Title: Permit 20-030- Crown College Ball Fields, Laketown Township

Prepared by: Name: Heidi Quinn
Phone: 952-641-4504
hquinn@minnehahacreek.org

Recommendation: Approval of MCWD permit application on the following conditions:

Sheet Title:
WETLAND BUFFER PLAN

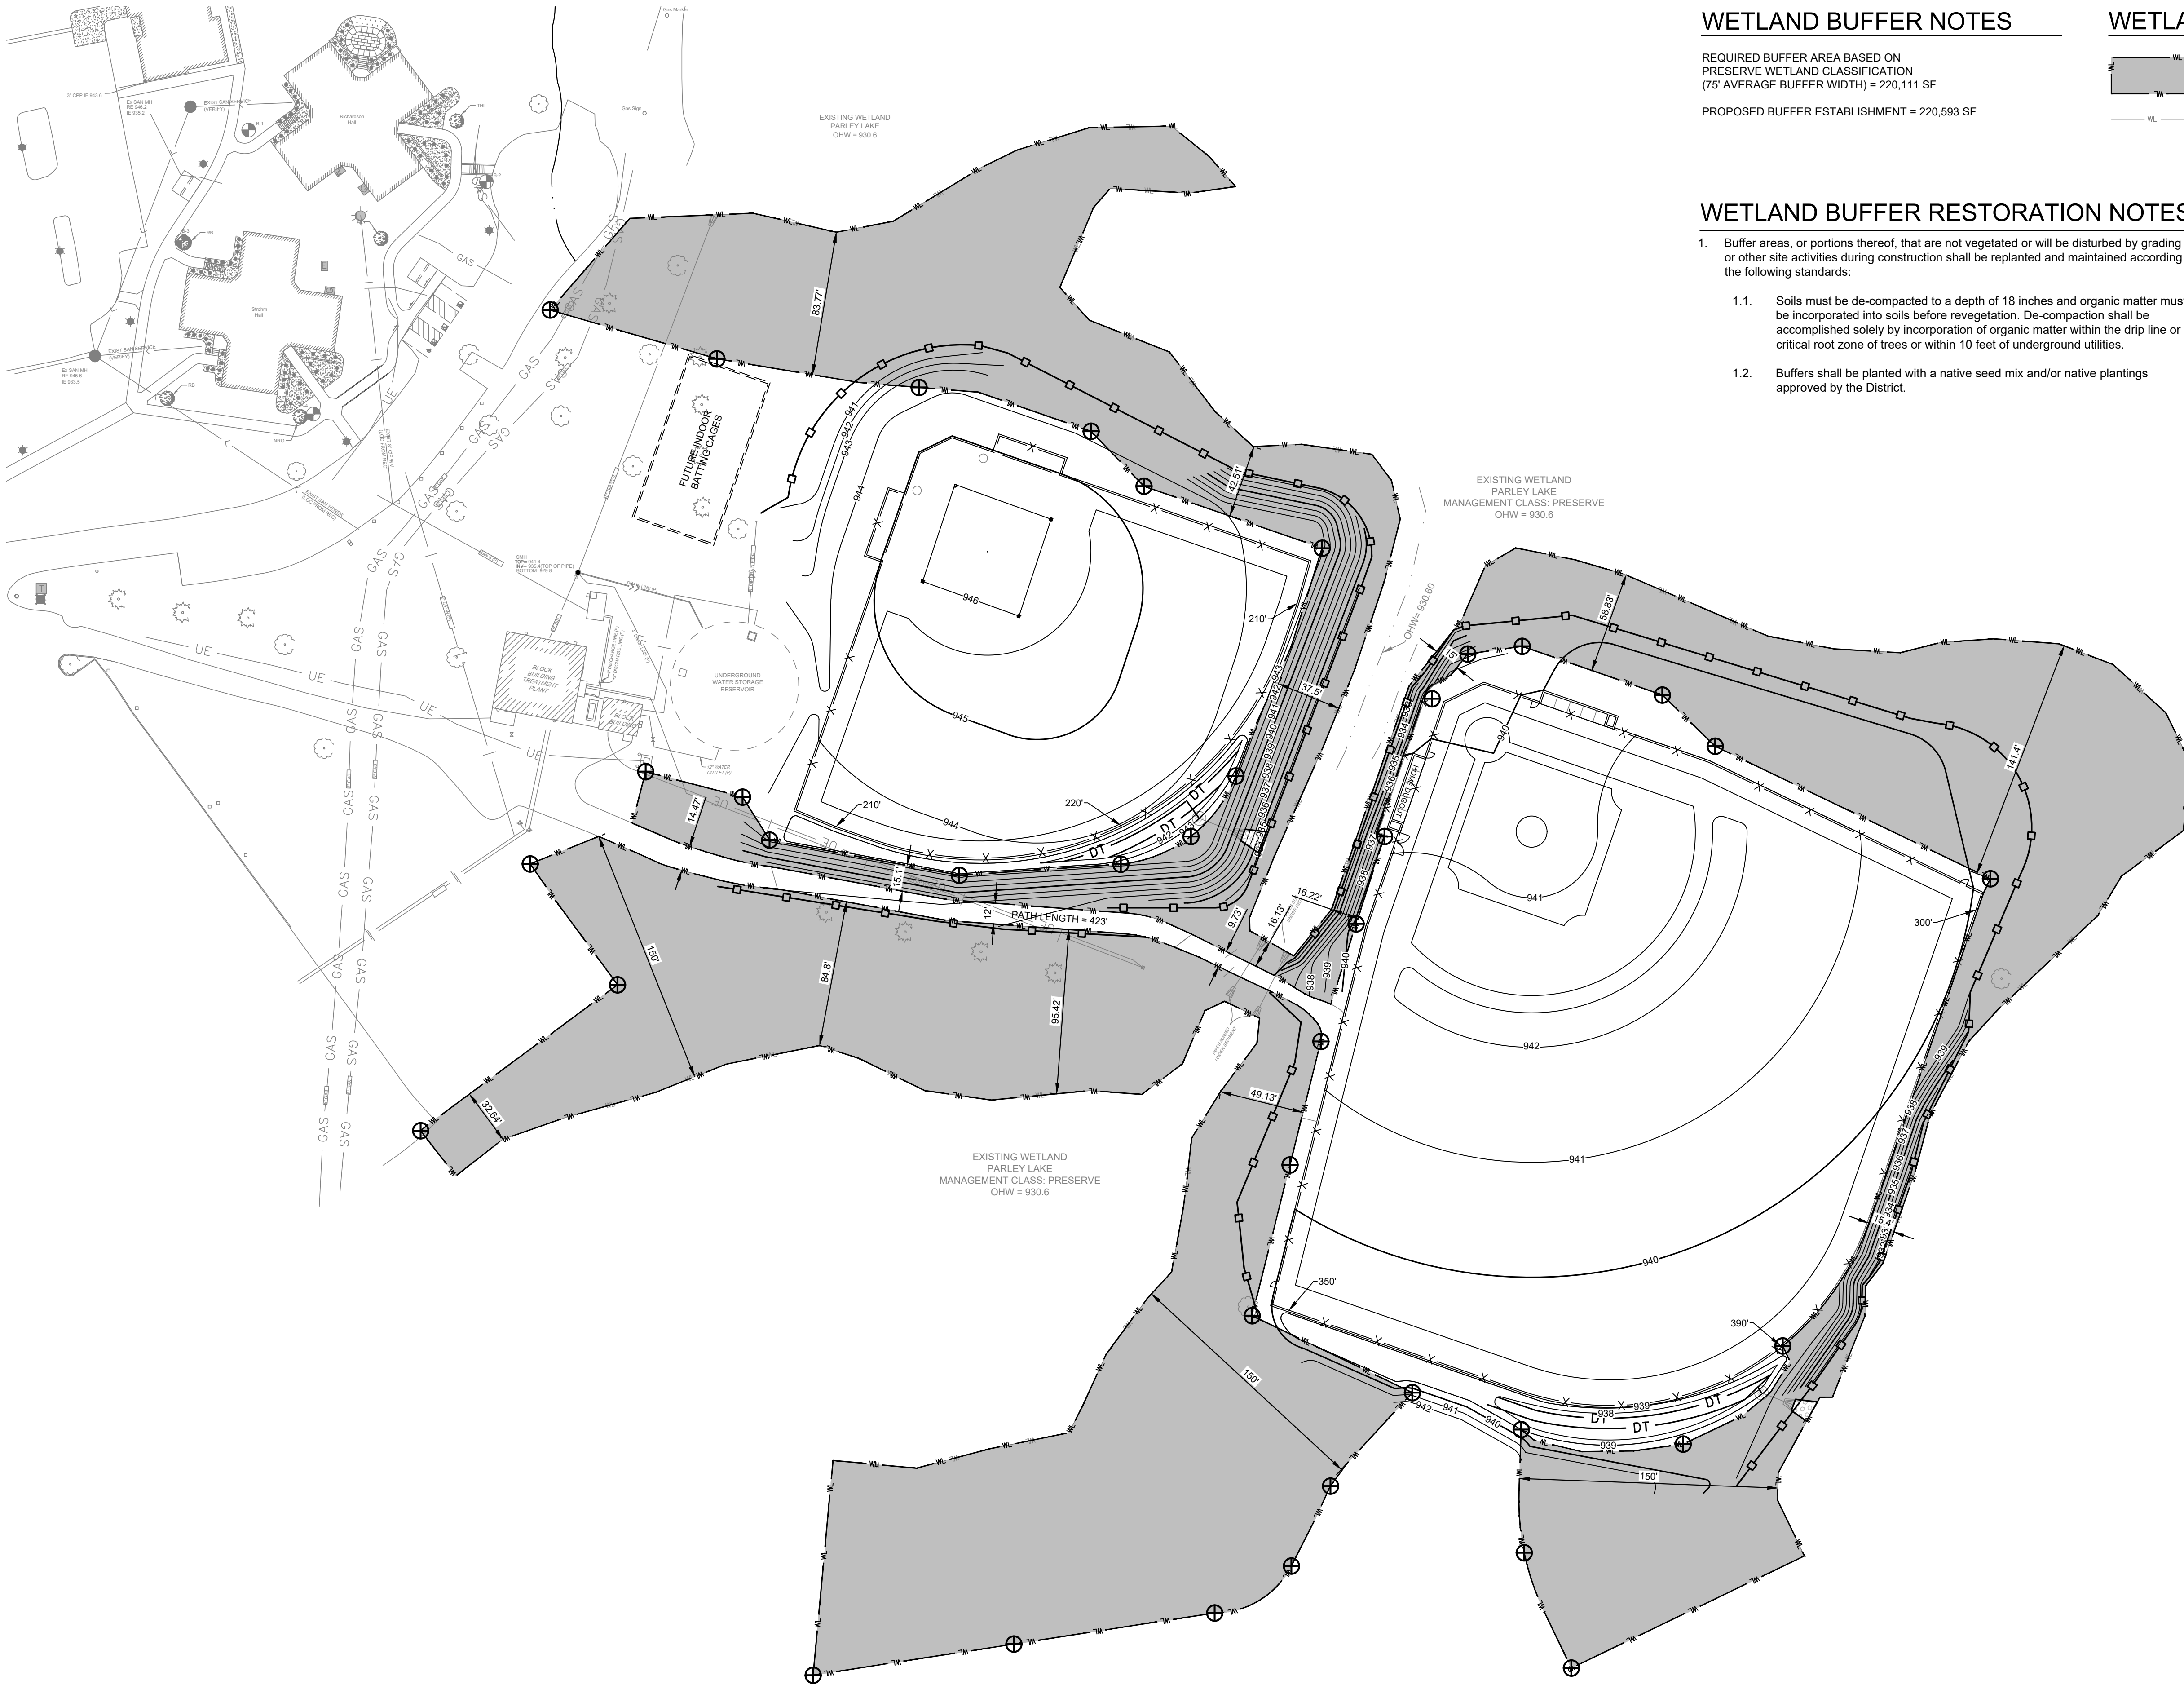
The Variance and Exception Rule allows the Board of Managers to grant variances from a provision of the rules based on the showing of the applicant in response to District Variance Standards. Section 2 of the Variance and Exception Rule outlines these standards. The Applicant has submitted a Variance Application (attachment 4) requesting a 22.5 foot shortfall from the minimum buffer width requirement of 37.5 feet per section (6c) of the Wetland Protection rule for maintaining a minimum buffer width of 50% of the applied buffer width at all points around. The 22.5 foot shortfall is at three locations adjacent to Wetland B; west of the baseball field, east of the baseball field, and at the existing trail crossing over the 3rd order stream. The three locations span a total of 495 feet. Table 5 summarizes the three buffer width shortfalls to Wetland B below.

Staff and the District Engineer have reviewed the wetland buffer plan and have determined that biological and ecological intent of the wetland buffer provision to provide habitat adjacent to wetlands have been provided and there is a shortfall of providing filtration of stormwater runoff prior to entering the wetland, which ultimately drains to Parley Lake.

Staff and District Engineer find that the Applicant has submitted sufficient evidence for the MCWD Board of Managers to support the managers' grant of a variance from section 3(c) of the Wetland Protection rule to provide a 15' wetland buffer in three locations for approximately a total of 495 linear feet.

1. Identification of the contractor responsible for implementing the erosion control plan;
2. Submission of a NPDES permit;
3. Submission of a wetland buffer establishment, maintenance, and monitoring plan for buffer areas, or portions thereof, that will be disturbed by grading or other site activities during construction;
4. Submission of draft maintenance declaration for stormwater management and wetland buffers for District approval, then recordation;
5. Submission of financial assurance for the Erosion Control rule, Stormwater Management rule, and Wetland Protection rule;
6. Reimbursement of District fees for public notice, engineering review, and legal review.
